**November 4, 2025
Addendum #1
FOR IMMEDIATE ATTENTION**

Reference – Invitation for Bid:	IFB #011-0-2026/SB Campus for Student Success Multi-Purpose Room Renovations
For Delivery To:	Newport News Public Schools
Bids Due:	November 14, 2025 at 2:00 PM EST

ADDENDUM NO. 1

Invitation to Bid: IFB #011-0-2026/SB
QE Project Number 42025321 Campus For Student Success Multi-Purpose Room Renovations
Receipt Date/Time: November 14, 2025, at 2:00 PM
Opening Date/Time: November 14, 2025, at 2:00 PM
Subject: Questions and Responses to Bidder questions, Specifications, and Drawings Revisions

SCALE: 1/8" = 1'-0"

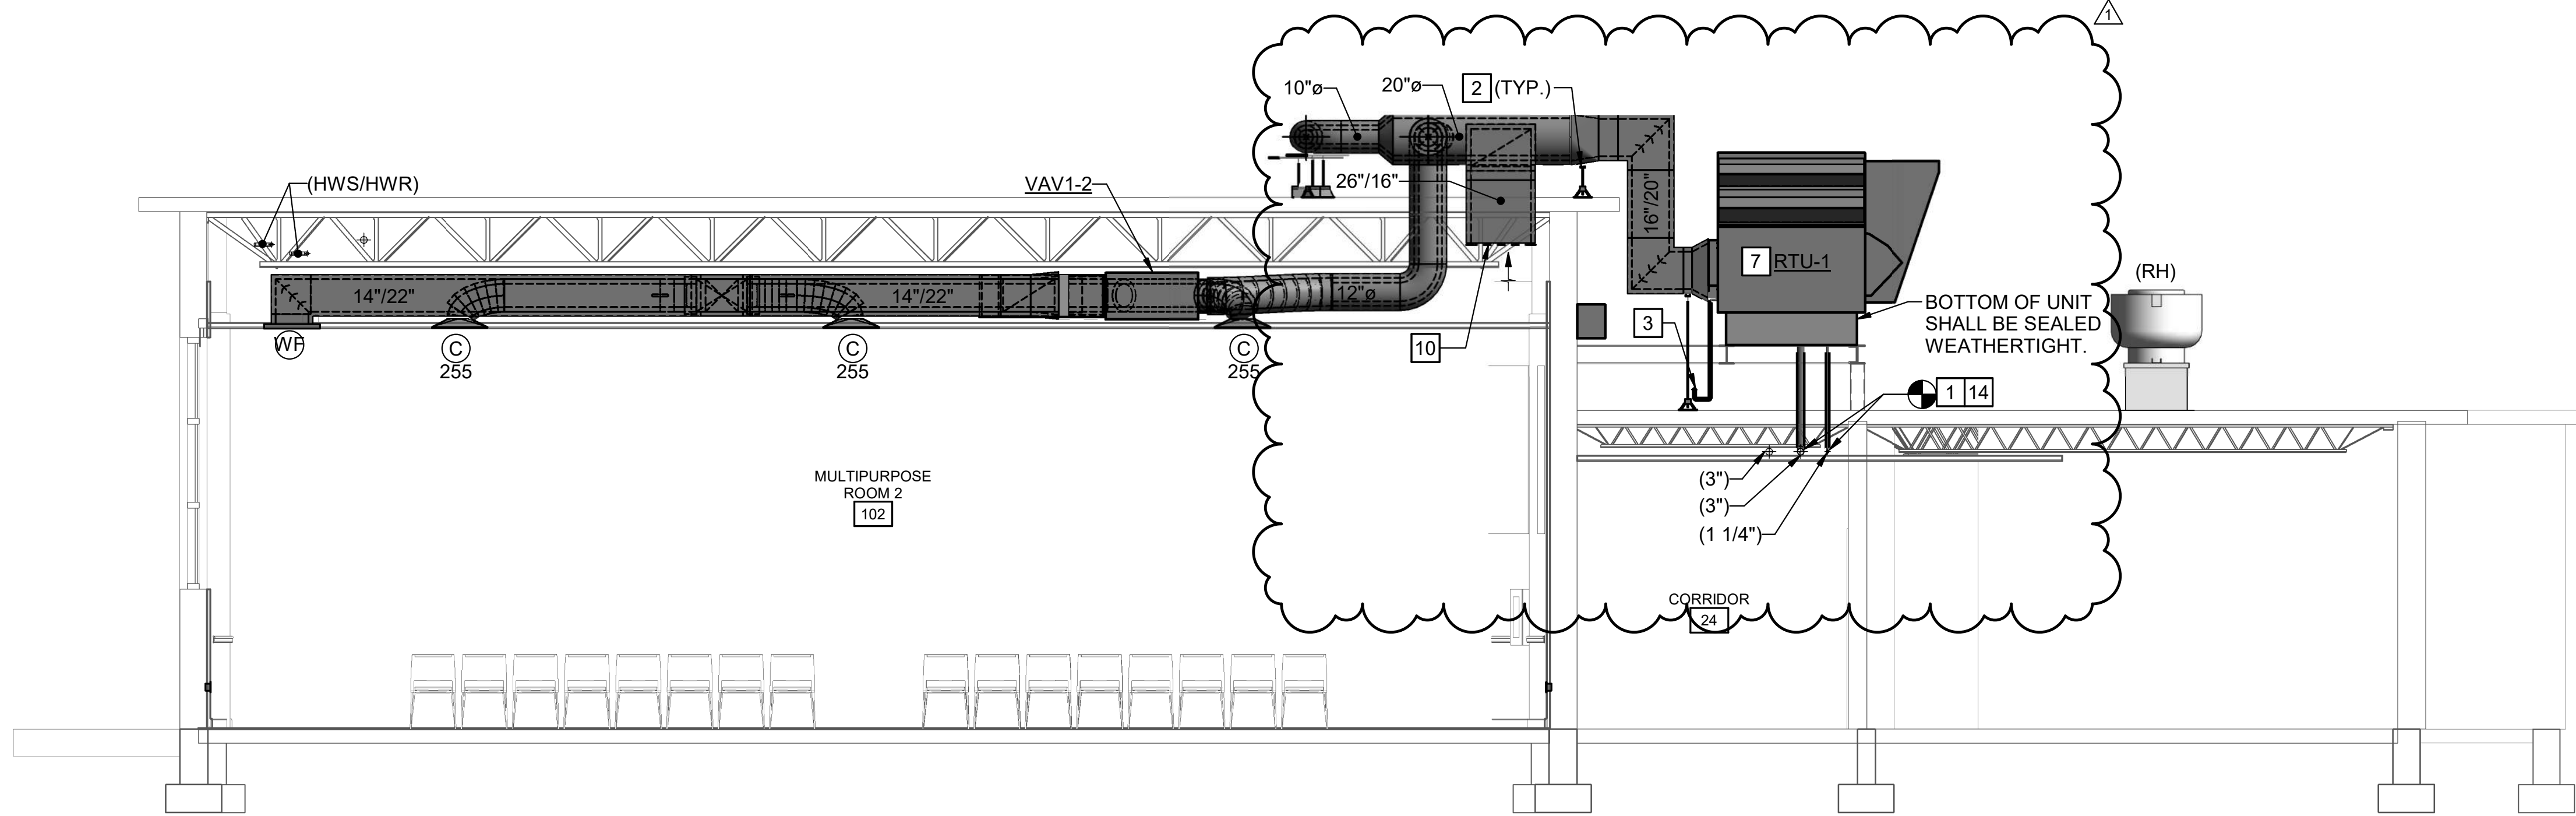
- i) **FLOOR PLANS – NEW WORK – MECHANICAL** – REVISED on drawings. Rooftop unit location shifted plan South along with ductwork modifications on the roof and on the floor plan. Section A revised to accommodate changes to floor plans. Indicated by revision triangle number 1.

- ii) **“NEW WORK NOTES”** Note 7 – REVISED to read “PROVIDE FULL PERIMETER RAIL WITH SPRING ISOLATORS. REFER TO “ROOFTOP UNIT SUPPORT AND VIBRATION ISOLATION DETAIL” ON DRAWING M402. Indicated by revision triangle number 1.

- iii) **“NEW WORK NOTES”** Note 14 – **ADDED:** CONTRACTOR SHALL CUT HOLE THROUGH ROOF FOR HOT WATER PIPING, INSULATE AND PROVIDE HEAT TRACE. CONTRACTOR TO PROVIDE PITCH POCKET, FLASH AND SEAL ALL PENETRATIONS WATERTIGHT. REFER TO HEAT TRACE DETAILS ON DRAWING M-402. Indicated by revision triangle number 1.

ROOFTOP UNIT SUPPORT AND VIBRATION ISOLATION DETAIL

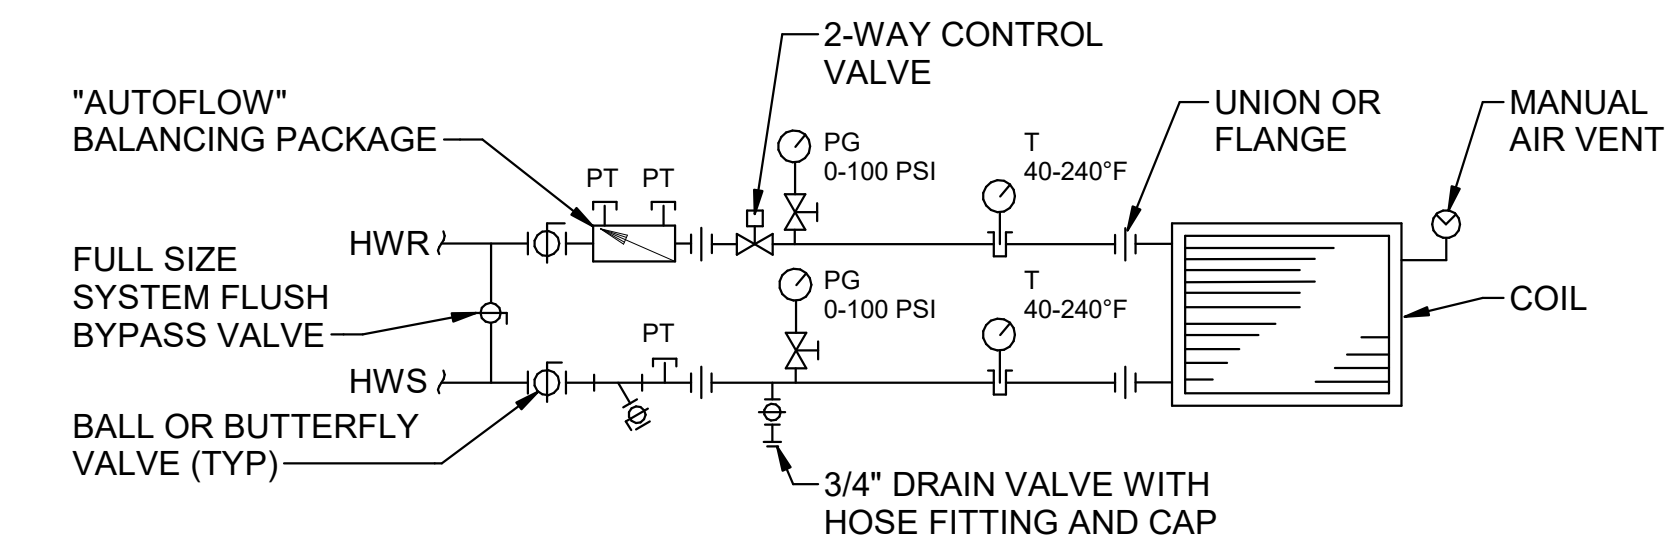
- i) **MECHANICAL DETAILS – REMOVED** detail on drawings. ROOFTOP UNIT MOUNTING DETAIL and **ADDED** “ROOFTOP UNIT SUPPORT AND VIBRATION ISOLATION DETAIL.” Indicated by revision triangle number 1.
- ii) **MECHANICAL DETAILS – ADDED** details on drawings. HEAT TRACE CABLE STAND OFF DETAIL,” “HEAT TRACE ORIENTATION DETAIL,” “TYPICAL HEAT TRACE CABLE – TEE FITTINGS DETAIL” AND “HEAT TRACE THERMOSTAT CONTROLLER DETAIL.” Indicated by revision triangle number 1.
